SUBJECT: FERMI, UNIT 2 - STAFF ASSESSMENT OF INFORMATION PROVIDED PURSUANT TO TITLE 10 OF THE *CODE OF FEDERAL REGULATIONS* PART 50, SECTION 50.54(f), SEISMIC HAZARD REEVALUATIONS FOR RECOMMENDATION 2.1 OF THE NEAR-TERM TASK FORCE REVIEW OF INSIGHTS FROM THE FUKUSHIMA DAI-ICHI ACCIDENT (TAC NO. MF3861)

Enclosure:  
Staff Assessment of Seismic  
Hazard Evaluation and Screening Report

FERMI, UNIT 2

Figure 3.3-1 Plot of Staff's and Licensee's Base Case Shear-Wave Velocity Profiles Used in SHSR for the Fermi 2 Site

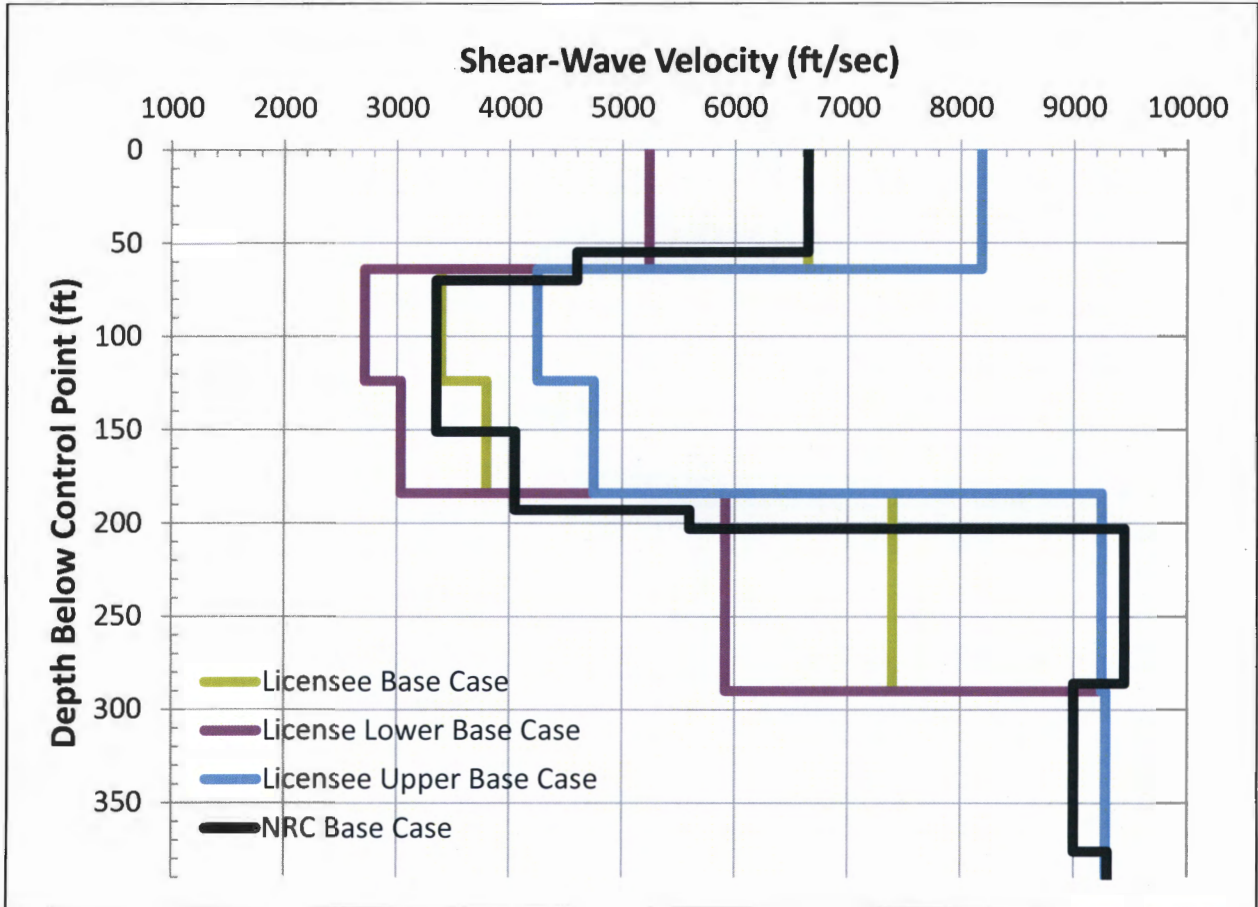
Because of the high quality of the data and the geologic consistency between Fermi 2 and proposed Fermi 3 the NRC staff's base case shear-wave velocity is based on the measured proposed Fermi 3 shear-wave velocity data. In addition, due to the consistencies between Fermi 2 and the proposed Fermi 3, the NRC staff used a single base case velocity profile rather than the three profiles developed by the licensee. Figure 3.3-1 of this assessment shows the NRC staff velocity profile compared to the base case profiles developed by the licensee.

The licensee's approach to damping and kappa differed significantly than expected by the NRC staff. The licensee chose to use two different, equally weighted damping profiles: EPRI rock and linear with a damping value dictated by the low strain damping derived from the EPRI rock curves. This approach resulted in significantly higher damping across the profile and corresponds to a Q of approximately 16, which is significantly lower than the value of 40 used by the NRC staff. By letter dated November 17, 2014 (NRC, 2014b), the NRC staff issued a request for additional information (RAI) to the licensee requesting a basis for the chosen damping parameters in light of the high seismic velocities and the sound rock at the site, as determined by detailed investigations for the proposed Unit 3.

By letter dated December 18, 2014 (Kaminskas, 2014), the licensee responded to the NRC staff's RAI stating that it revised its site response approach to be more consistent with the approach used for the proposed Fermi Unit 3. This revision includes reducing the amount of damping in the profiles and adding an additional profile that accommodated additional uncertainty in the depth to reference rock. The licensee stated that this approach, and the resulting Foundation Input Response Spectrum (FIRS), would be used for subsequent evaluations and confirmations, as needed for the response to the 50.54(f) letter. The NRC staff reviewed the information provided in the licensee's response. The reduced damping values provided in the response are consistent with the damping values in the Fermi 3 SAR and those

expected by the NRC staff. Further, the additional profile accounts for epistemic uncertainty in the depth to reference rock. The NRC staff reviewed the information provided in the licensee's RAI response and by letter dated May 6, 2015 (NRC, 2015), the NRC staff asked the licensee to provide additional information regarding the revised inputs into the site response analysis. Specifically, the NRC staff asked the licensee to provide detailed velocity profiles, shear modulus degradation and damping curves, and updated site kappas. The NRC staff also requested that the licensee provide updated control point seismic hazard curves and an updated control point GMRS.

Figure 3.3- 2 Plot Comparing the Staff's and the Licensee's Median Amplification Functions and Uncertainties Presented in the SHSR for the Fermi 2 Site

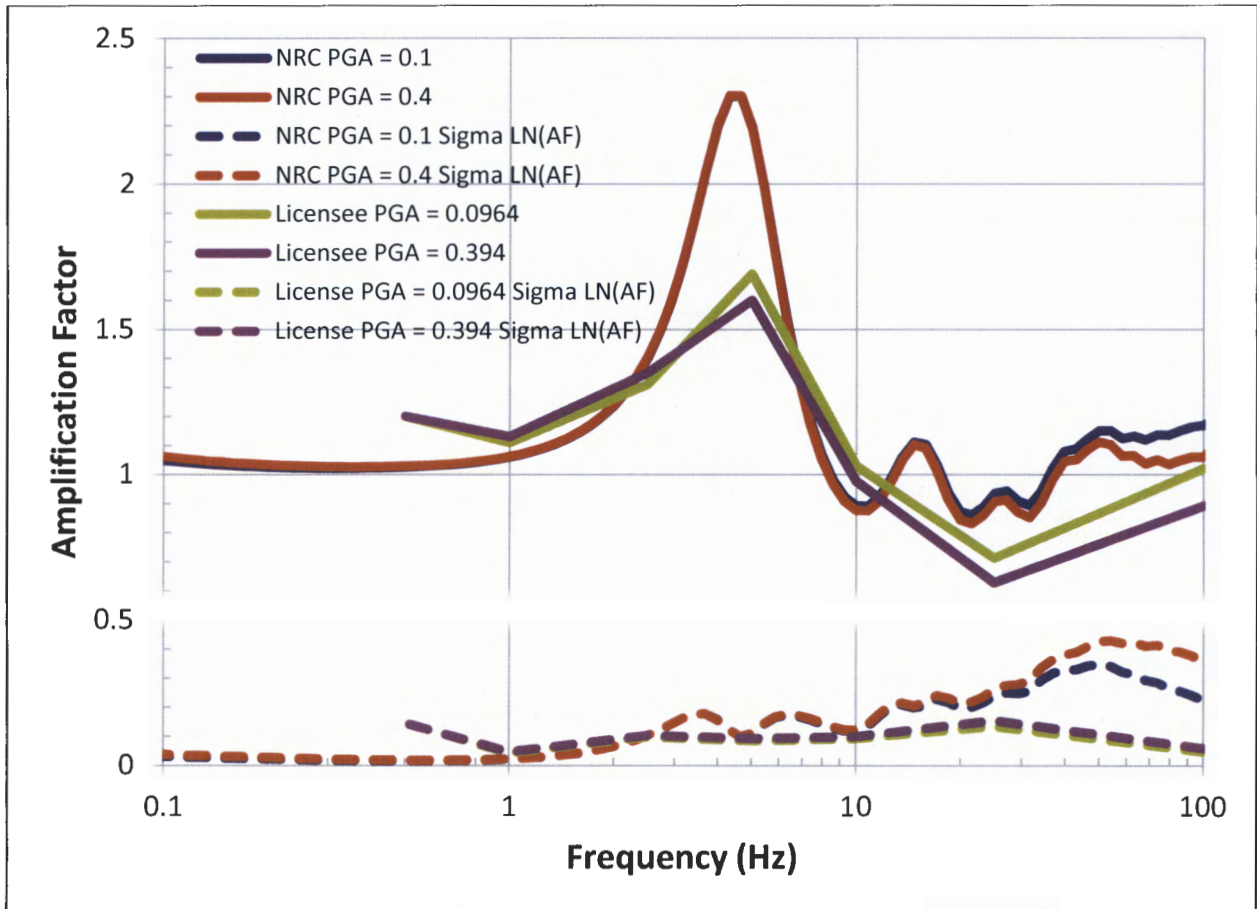
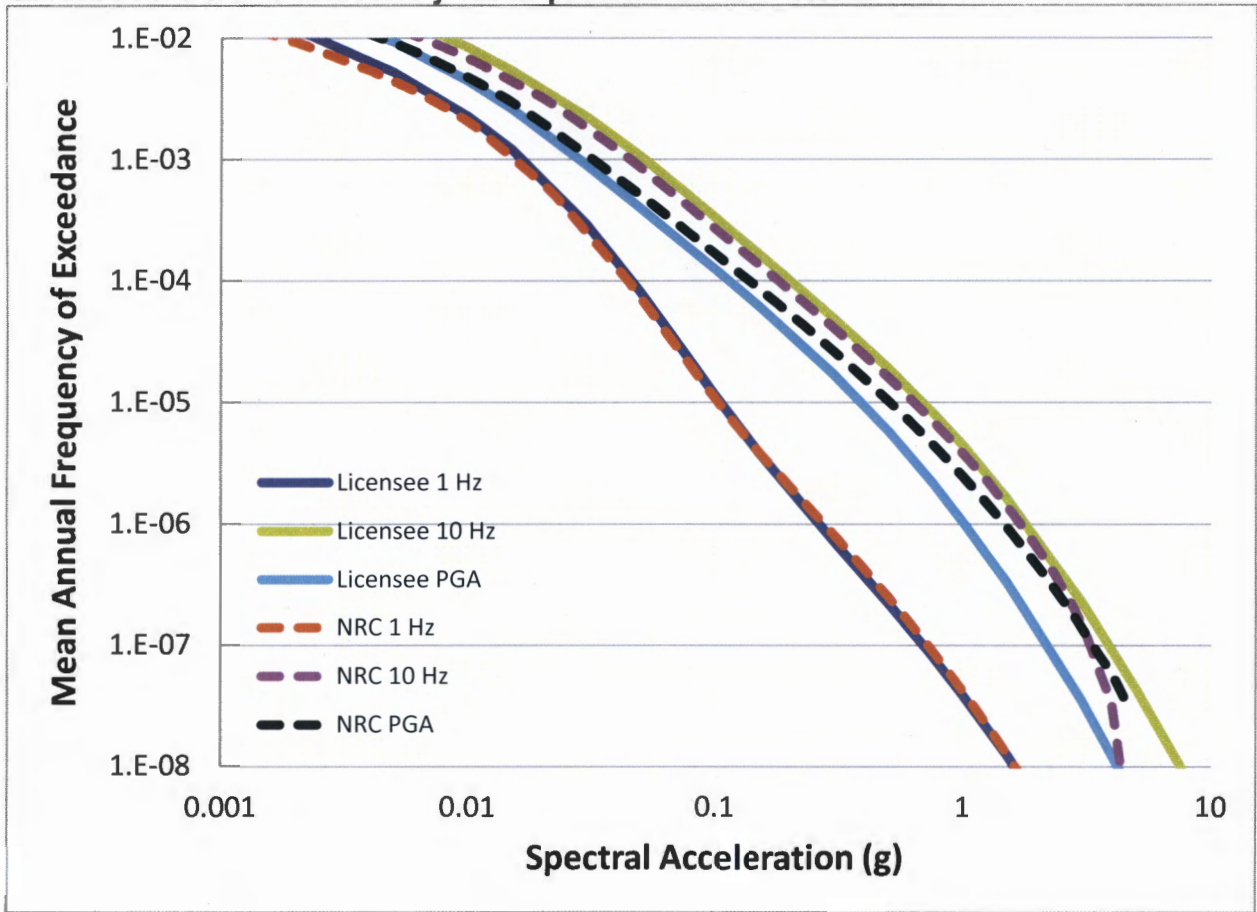
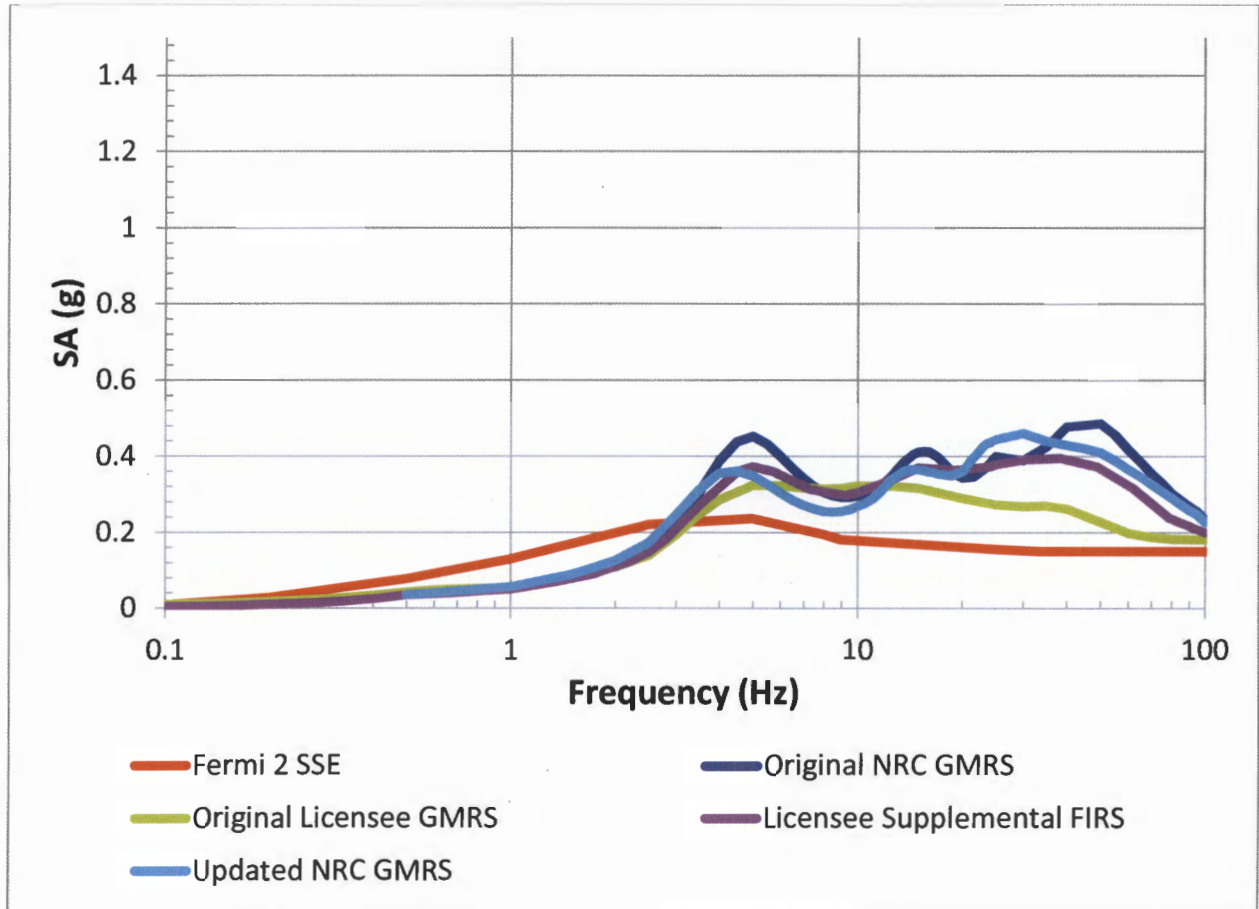
Figure 3.3-2 of this assessment shows a comparison of the NRC staff's and licensee's median site amplification functions and uncertainties ( $\pm 1$  standard deviation) for two of the eleven input loading levels for profiles used in the licensee's SHSR submittal. The licensee's site amplification functions shown in Figure 3.3-2 of this assessment are for its original site response analysis and not the updated functions. Peaks in amplification functions occur between 3 and 5 Hz in both staff and licensee curves. The peak amplification factors between 3 and 5 Hz calculated by the NRC staff are approximately 1.4 times that calculated by the licensee. These differences are due to the higher damping values used by the licensee for its original site response analysis.
